**Harker Heights  
Planning and Zoning  
Commission Meeting**

**Wednesday,  
February 24, 2021  
6:30 P.M.**

## PLANNING AND ZONING COMMISSION MEMORANDUM

**DISCUSS AND CONSIDER A REQUEST FOR CONCEPT PLAN REFERRED TO AS THE ENCLAVE AT INDIAN TRAIL ON PROPERTY DESCRIBED AS, A1086BC W.E. HALL, ACRES 2.649, A0723BC J.M. ROBERTS, & A-1086 W.E. HALL, ACRES 3.003, A1086BC W.E. HALL, ACRES 7.917, AND CENTEX WASTE MANAGEMENT DEVELOPMENT PHASE TWO, BLOCK 001, LOT PT 4, (SW PT OF 4), ACRES 2.980, GENERALLY LOCATED EAST OF INDIAN TRAIL (FM 3423) DIRECTLY BEHIND HARKER HEIGHTS CENTRAL FIRE STATION, HARKER HEIGHTS, BELL COUNTY, TEXAS.**

# CONCEPT PLAN: THE ENCLAVE AT INDIAN TRAIL

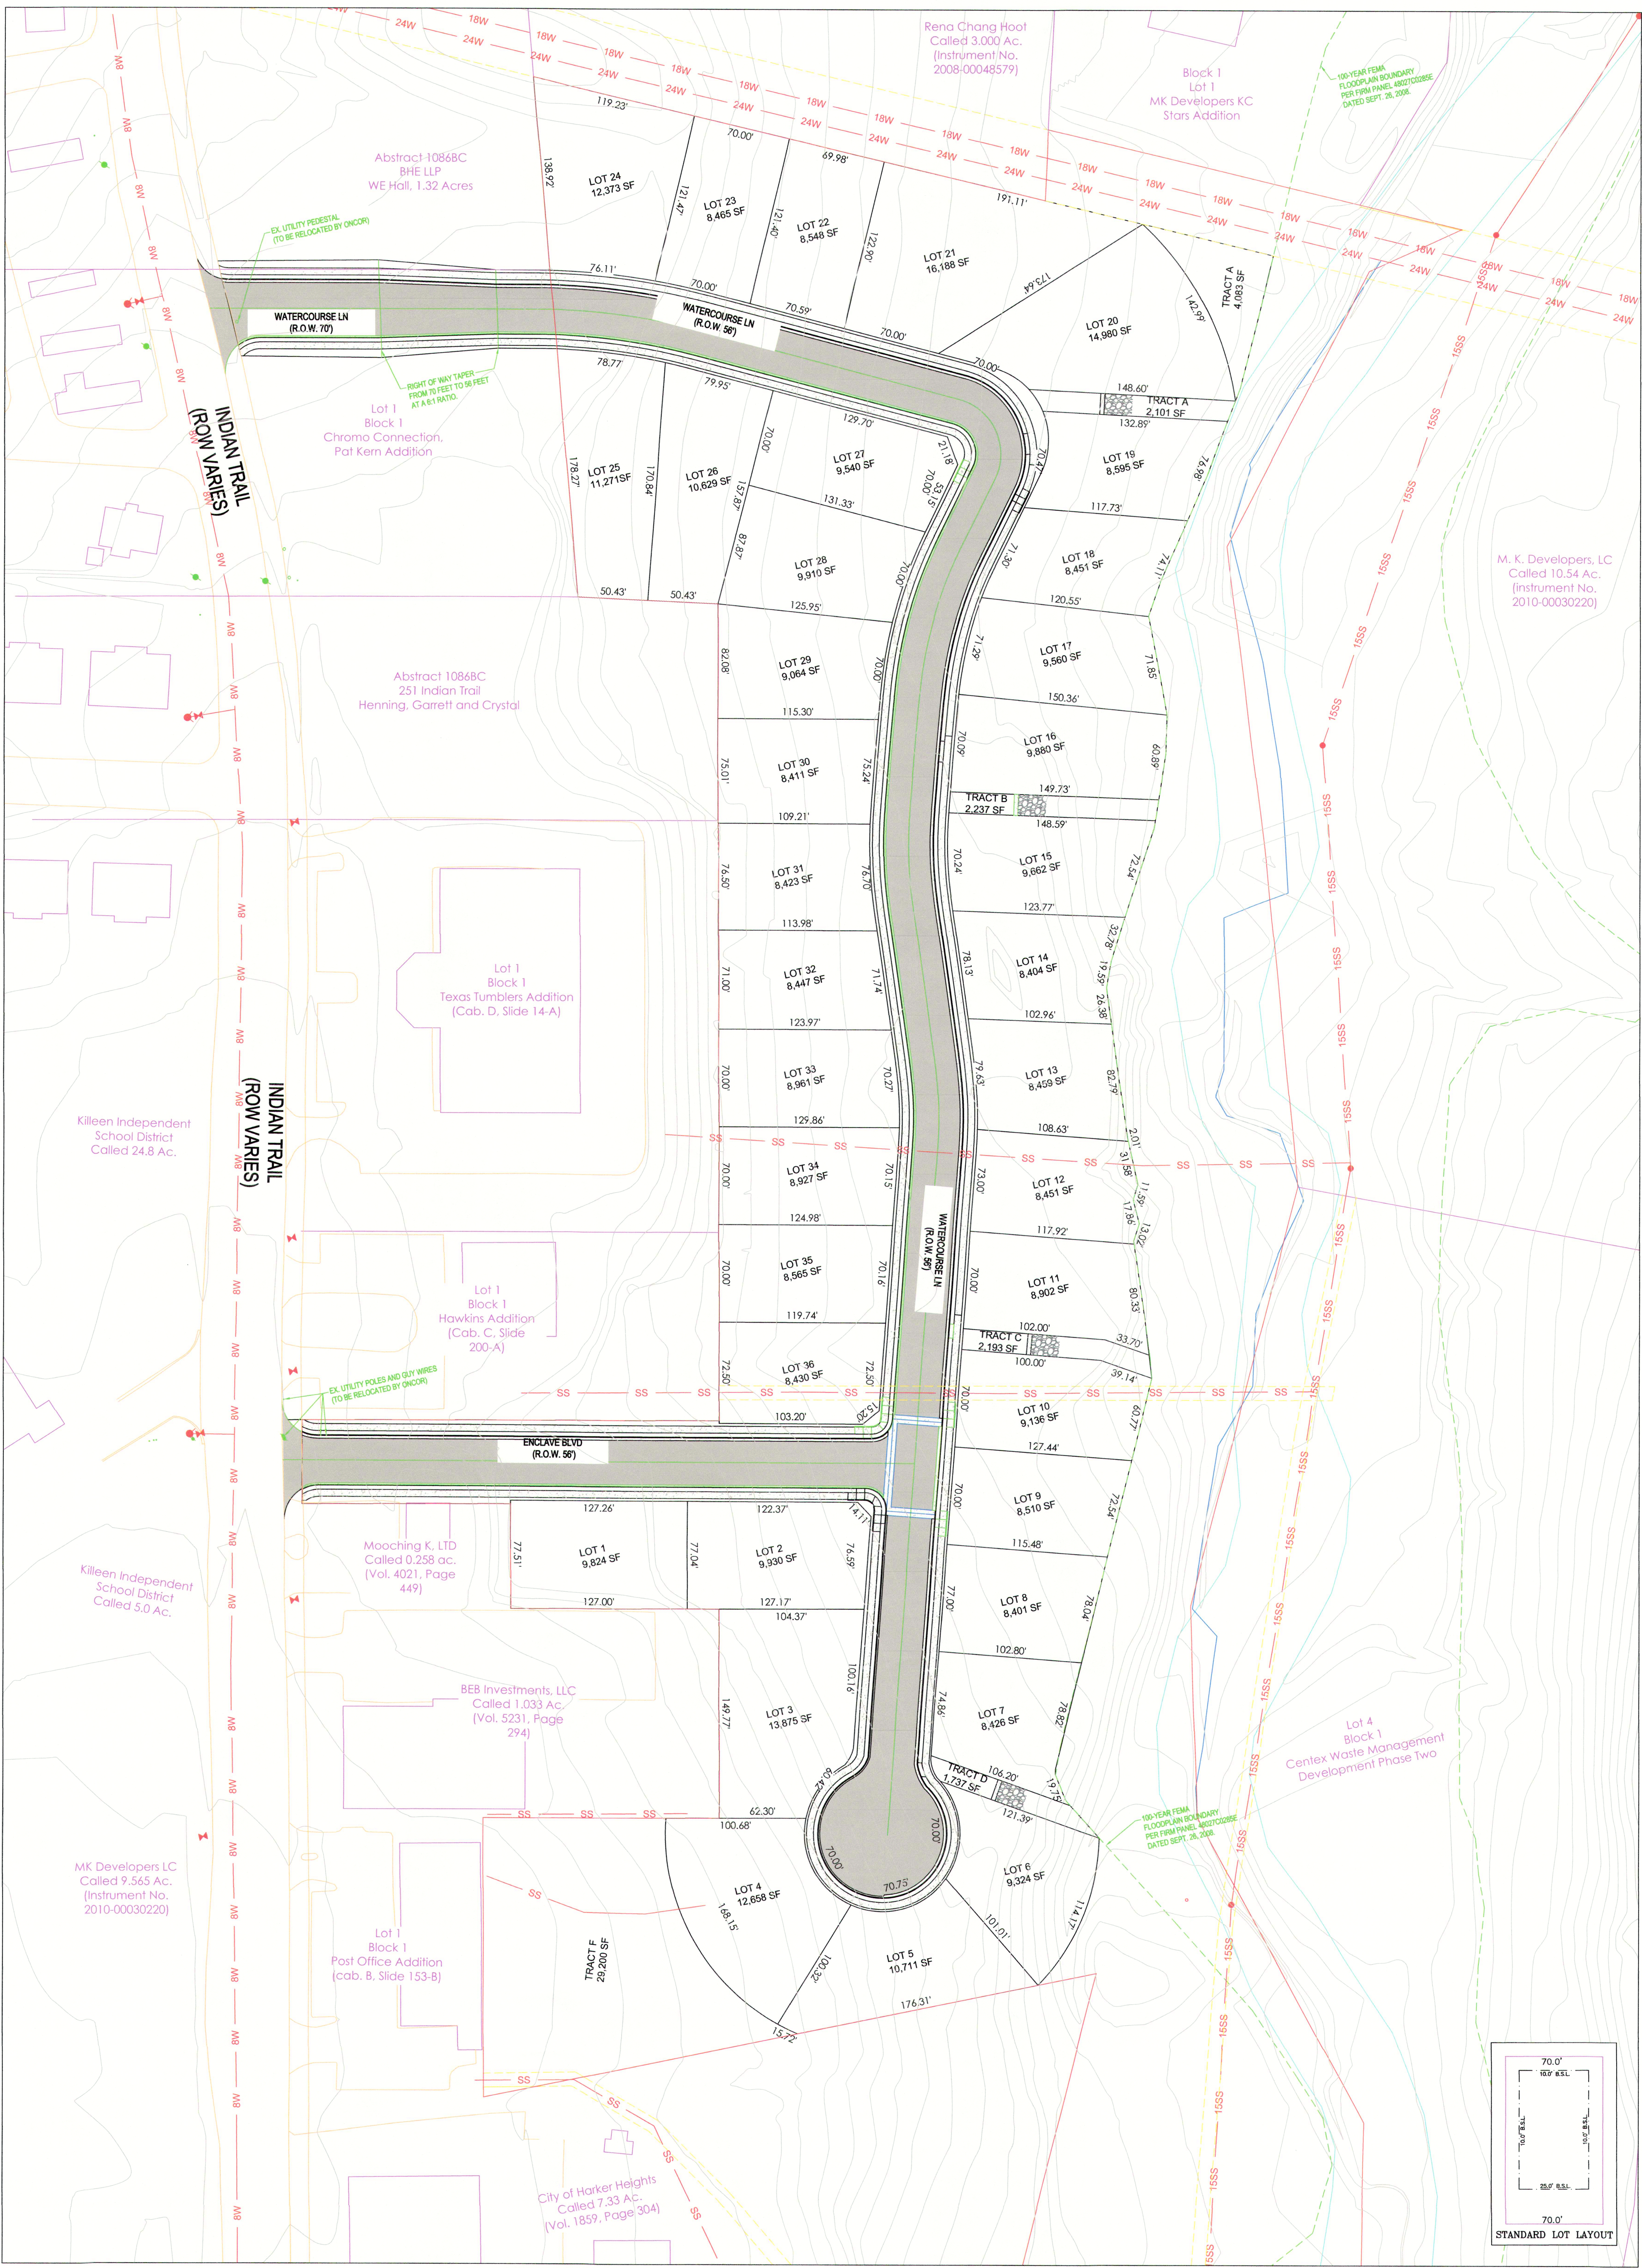
1. The parcels within the submitted Concept Plan are currently zoned PD-R with an underlying R-1A (Ordinance 2016-05). It is staff's understanding that this concept plan was submitted concurrently with a zoning case for a PD-R with an underlying R-2. Please provide a copy of the variances being requested in the new PD-R, so that staff may verify compliance with those items.

5. Per Section 154.20(A)(2)(d)(5), applicant shall identify which properties (tracts) are intended to be dedicated to the City of Harker Heights, the land use for the adjoining properties for a distance of 300 feet and provide a Note on the concept plan that identifies all lots as R-2 (Duplex) Development.

7. Per Section 154.20(A)(2)(d)(7), applicant shall provide a parking layout. This can be illustrated within a Typical Lot Layout.
8. Per Section 154.20(A)(2)(d)(8), applicant shall clarify if there is any proposed general landscaping or buffer areas for this development.

9. Per Section 154.20(A)(2)(d)(9), applicant shall provide location of all existing and **proposed** water and sewer lines.

10. Per Section 154.20(A)(2)(d)(10), applicant shall illustrate and annotate all existing and proposed public utility easements and private easements. Please annotate/provide callouts (i.e., "U.E, D.E., P.U.E.) for all existing and proposed easements (utility, drainage, access, etc.).
11. Per Section 154.20(A)(2)(d)(15), applicant shall provide the location of all existing and proposed fire hydrants.

1. Annotate the width of the streets on the plan view drawings. Residential streets are required to be 36' wide measured from back of curb with a 60-foot right of way.

2. Main street entrances shall be 42 feet wide with a 70-foot right-of-way for a minimum distance of 100 feet from the intersection.
3. Annotate the width of the sidewalks on the drawing.

4. Provide locations of all existing and proposed water lines, sanitary sewer lines and storm sewer lines.
5. Provide locations of fire hydrants.
6. This section of Indian Trail (FM 3423) is maintained by TxDOT. Utility Installation Permits for water bore(s) will be required.

7. Provide all existing and/or proposed public utility easements and private easements.
8. Provide all existing and proposed stormwater drainage easements or onsite detention plan.

1. TxDOT will allow the northern access only for the residential subdivision access. The southern access shall be for emergency (fire use) use only and shall be gated and signed as no public access. The gate may be a "crash gate" or simply a locked gate to prevent public access. A traffic impact analysis is required for this development.
